BOARD OF SUPERVISORS COUNTY OF INYO

RE: U.S. Nuclear Regulatory Commission's Supplement to the U.S. Department of Energy's Environmental Impact Statement for a Geologic Repository for the Disposal of Spent Nuclear Fuel and High-Level Radioactive Waste at Yucca Mountain, Nye County, Nevada Final Report (Docket ID NRC-2015-0051)

Subject: Summary of Review – Supplement to the U.S. Department of Energy’s Environmental Impact Statement for a Geologic Repository at Yucca Mountain, Nevada

Figure 3-10. Pumping vs. Time, Pahrump Valley, Nevada

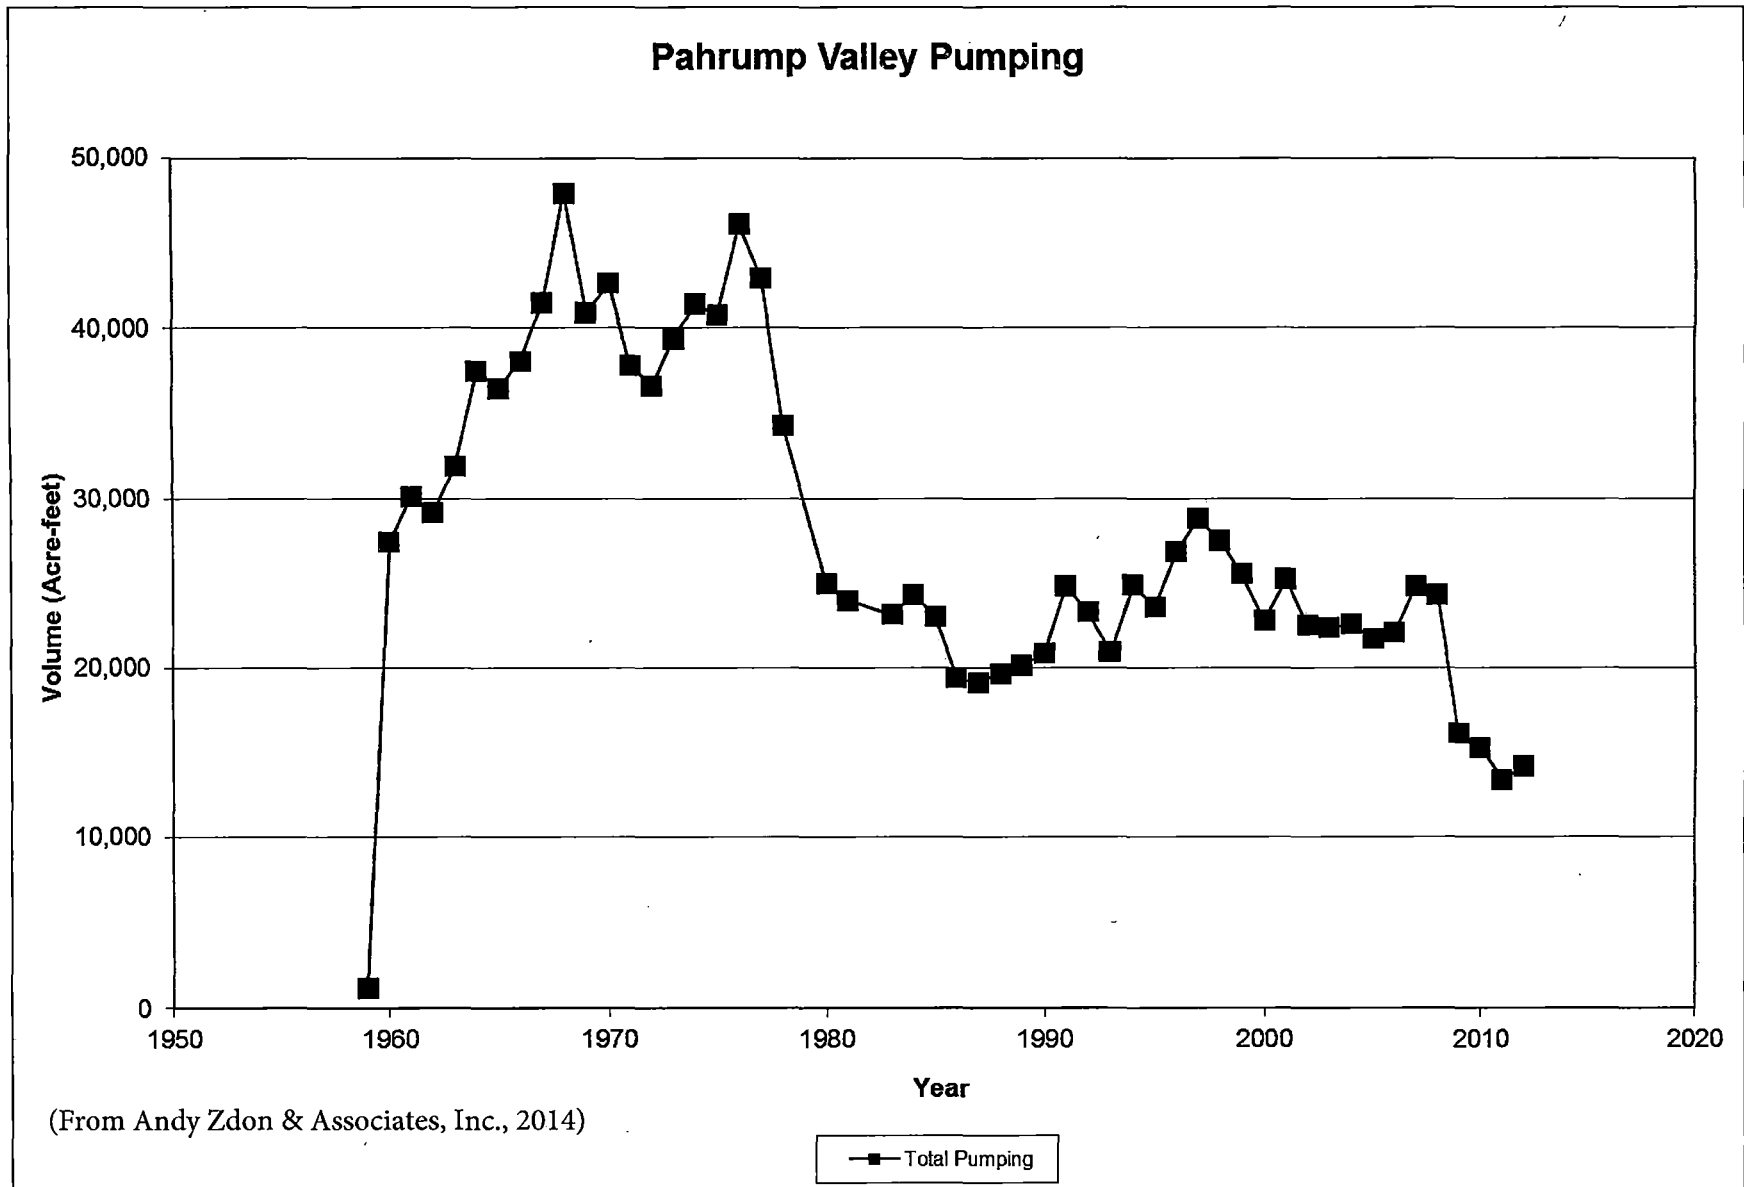
1. The Final Report continues with the flawed assumption (e.g., Section 2.1.1) that population and associated groundwater usage will continue as currently being used despite upward trends in groundwater usage in Amargosa Desert and past history showing that substantial changes to groundwater usage can occur in this region under very short time frames, as illustrated by the history of groundwater pumping in Pahrump Valley (see attached).
